1959 - 1961 Corvette: Service News: Fuel Injection Change

Subject: Fuel Injection Change
Model and Year: 1959 - 1961 Corvette
Source: Chevrolet Service News
Page Number: 1
Date: July, 1961 - Volume 33 - Number 7

Fig. 2—Fuel Injection Cold Enrichment

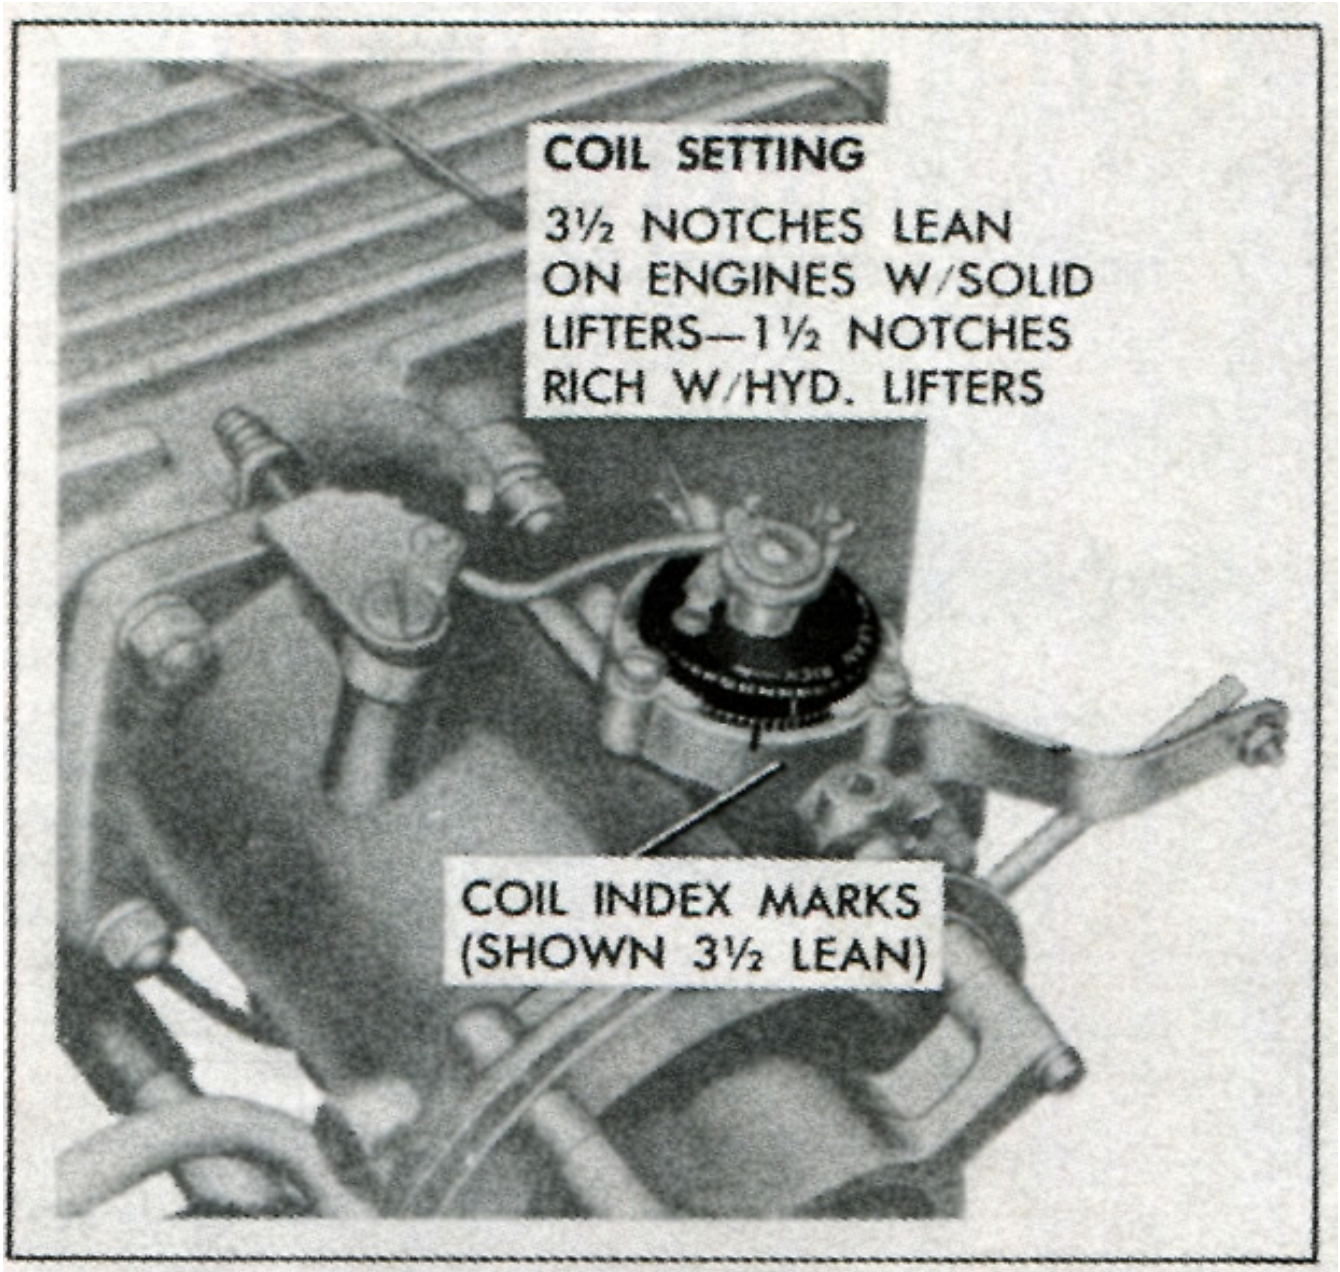
On 290 hp Corvette engines used in 1959 and 315 hp used in 1960 - 1961, the cover setting of the fuel injection thermostatic coil, that provides cold engine fuel enrichment, should be adjusted to 3 1/2 notches lean from the index mark on the cold enrichment housing (Fig. 2). The cold enrichment coil setting of 1 1/2 notches rich will still be used on all fuel injection engines of lower horsepower.
